# PERMIT

has permission to Additon of Shed Dormer - 7' 10"

AT 52 GRAY ST 044 H006001

PROJECT: 17 WINTER STREET  
 3rd FLOOR DORMER AND ROOF  
 STRUCTURAL DESIGN

1  
 DESIGN NUMBER:  
**SK-S1**  
 SHEET 1 OF 1

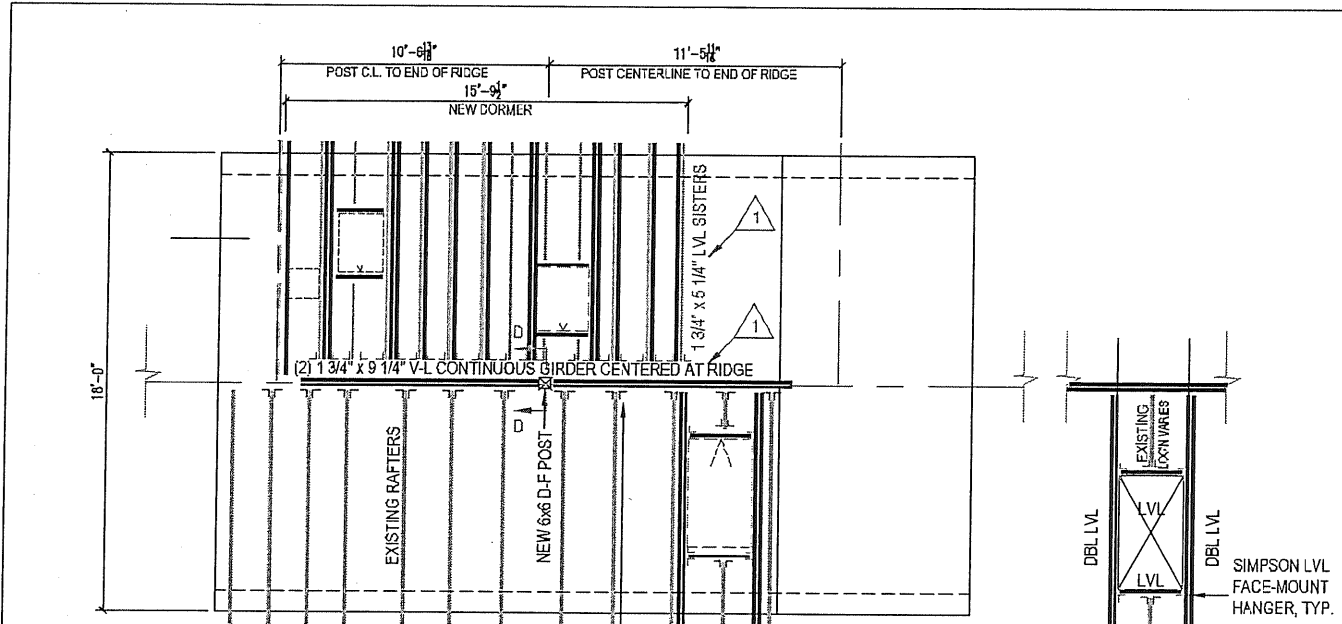
27 AUG 08  
 CLARIFICATIONS AND  
 FIELD MODIFICATIONS

**BUILDER NOTE: CONTACT ENGINEER PRIOR TO INSTALLING RIDGE TO VIEW CONDITIONS NOW COVERED BY DRYWALL**

SIMPSON HU 26-2 OR HU46 HANGER AS REQUIRED AT EXIST. RAFTERS

VELUX MODEL GPL M08 EGRESS WINDOW  
 31 1/2" x 55 1/2" ROUGH OPENING  
 REMOVE DRYWALL FINISH IN SURROUNDING AREA TO PERMIT ADJACENT FRAMING INSPECTION  
 SEE SHEET S1.2 FOR OTHER WINDOWS

NOTE: LOCATIONS SHOWN APPROXIMATE. FIELD VERIFY ALL DIMENSIONS.  
 NOTE: FOR CONSTRUCTABILITY, TWO 1 3/4" x 9 1/4" LVL MAY BE SUBSTITUTED FOR RIDGE

DRAWING NUMBER  
**S1.3**  
 SHEET 3 OF 4

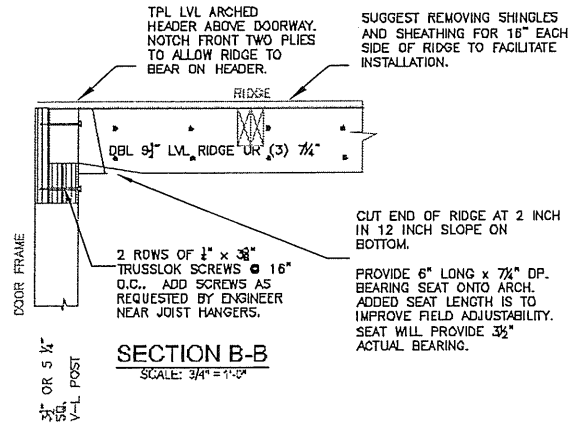
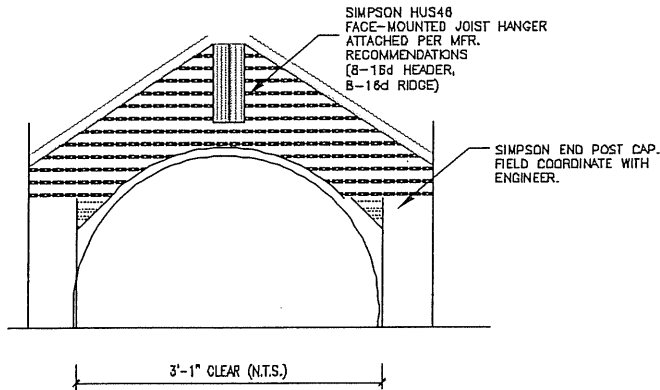
27 AUG 08  
 CLARIFICATIONS AND  
 FIELD MODIFICATIONS

**BUILDER NOTE: CONTACT ENGINEER PRIOR TO INSTALLING RIDGE TO VIEW CONDITIONS NOW COVERED BY DRYWALL**

CONTRACTOR MAY USE TRIPLE 7 1/4" OR DOUBLE 8 1/4"

CUT END OF RIDGE AT 2 INCH IN 12 INCH SLOPE ON BOTTOM.  
 PROVIDE 6" LONG x 7/4" DP. BEARING SEAT ONTO ARCH. ADDED SEAT LENGTH IS TO IMPROVE FIELD ADJUSTABILITY. SEAT WILL PROVIDE 3/2" ACTUAL BEARING.

**1** PROPOSED THIRD FLOOR PLAN  
1/4" = 1'-0"

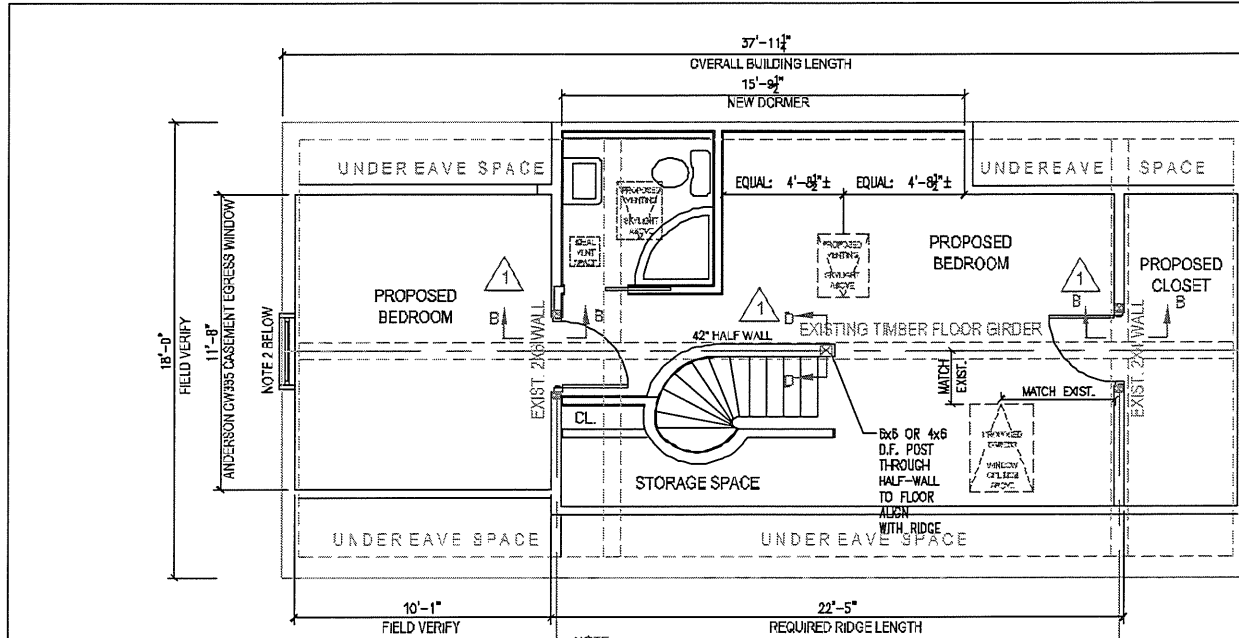
27 AUG 08  
 CLARIFICATIONS AND  
 FIELD MODIFICATIONS

- NOTE**
1. THIS PLAN IS PROVIDED FOR REFERENCE PURPOSES ONLY AND IS BASED UPON LAYOUT DESCRIBED BY OWNER AND CONTRACTOR. EGRESS DESIGN CONSISTS OF WINDOWS SHOWN ON PLANS. OTHER DESIGN IS FOR STRUCTURAL CONSIDERATIONS ONLY.
  2. GRAY STREET EGRESS WINDOW IS ANDERSON CW395 CASEMENT, WITH MULLION TO MATCH EXISTING HISTORIC PROFILE.
  3. WINTER STREET EGRESS WINDOW IS VELUX GPL 100, CENTERED ON EXISTING SKYLIGHT OPENING. BOTTOM OF NEW EGRESS WINDOW APPROX. 2'-6" A.F.F. (4" REQUIRED).
  4. BATHROOM SKYLIGHT IS VELUX MODEL V3101 (R.O. 20" x 27 1/2").
  5. BEDROOM SKYLIGHT IS VELUX MODEL F5007 (R.O. 30 3/4" x 31").
  6. BATHROOM EXHAUST IS BROWN QTR870 ULTRA-SILENT VENT FAN.
  7. 6x6 OR 4x6 DOUGLAS FIR POST. ALIGN WITH RIDGE AND EXTEND DOWN TO FLOOR AT BASE OF HALF-WALL. MAINTAIN WITHIN EXISTING HALF-WALL TO EXTENT POSSIBLE.
